HIGH-SPEED ROUNDABOUT APPROACH

Figure 12QQ

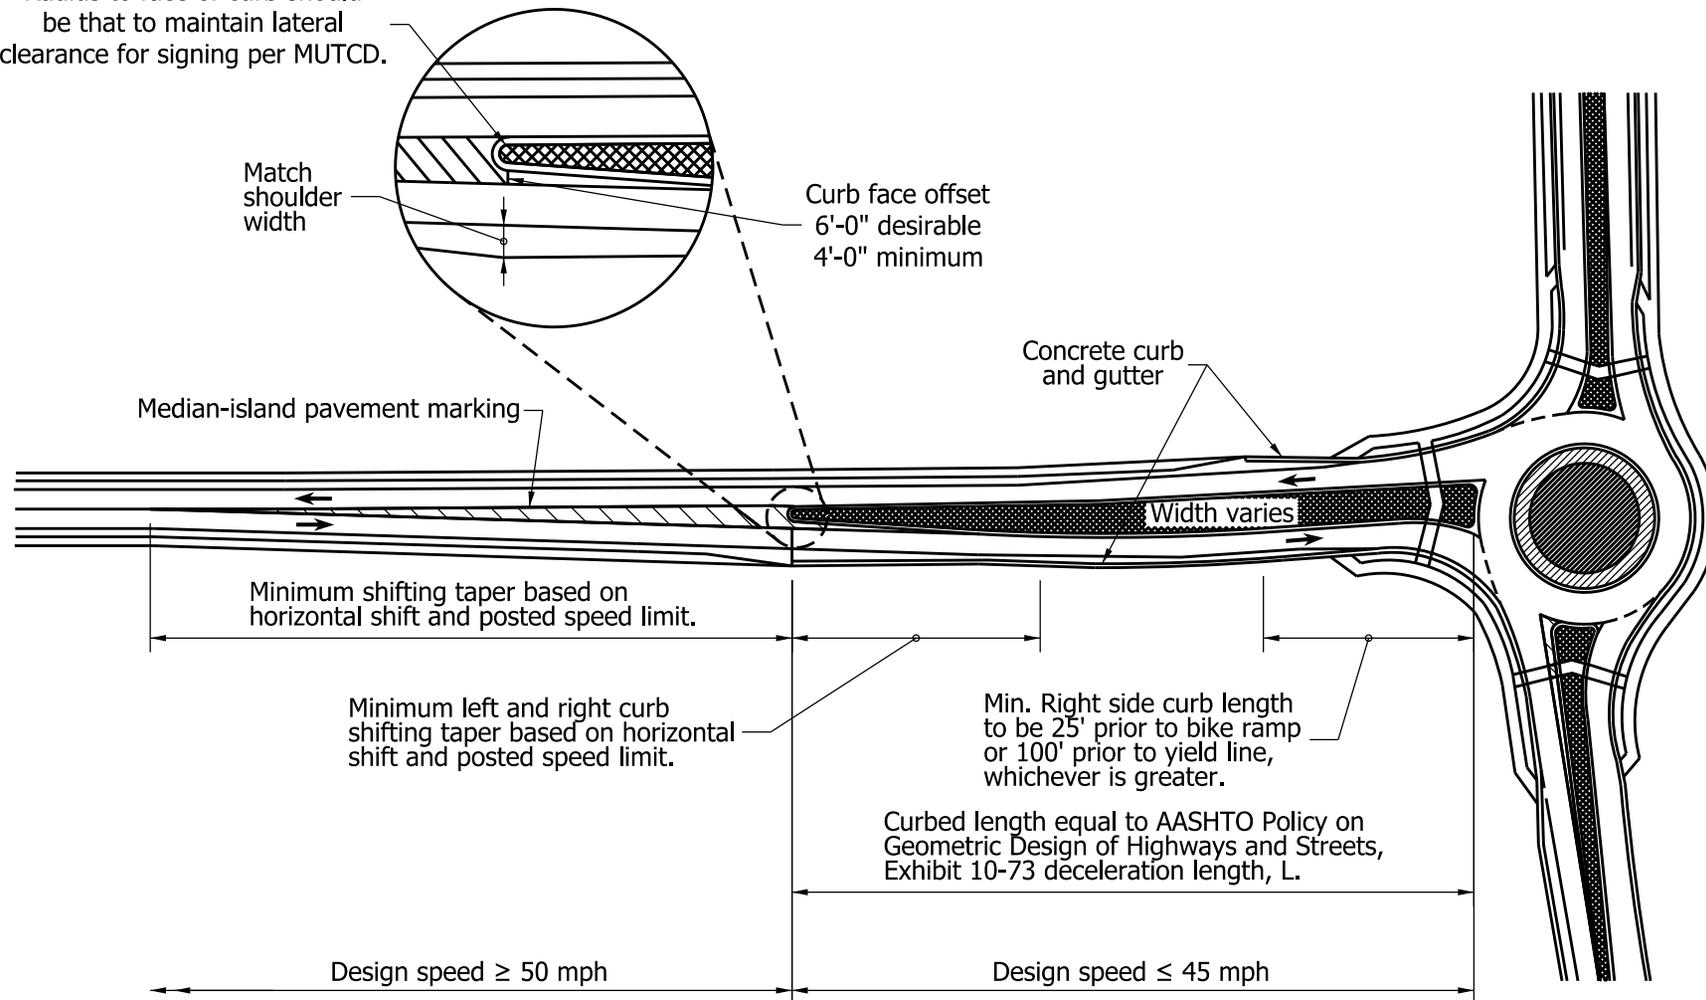
Radius to face of curb should be that to maintain lateral clearance for signing per MUTCD.
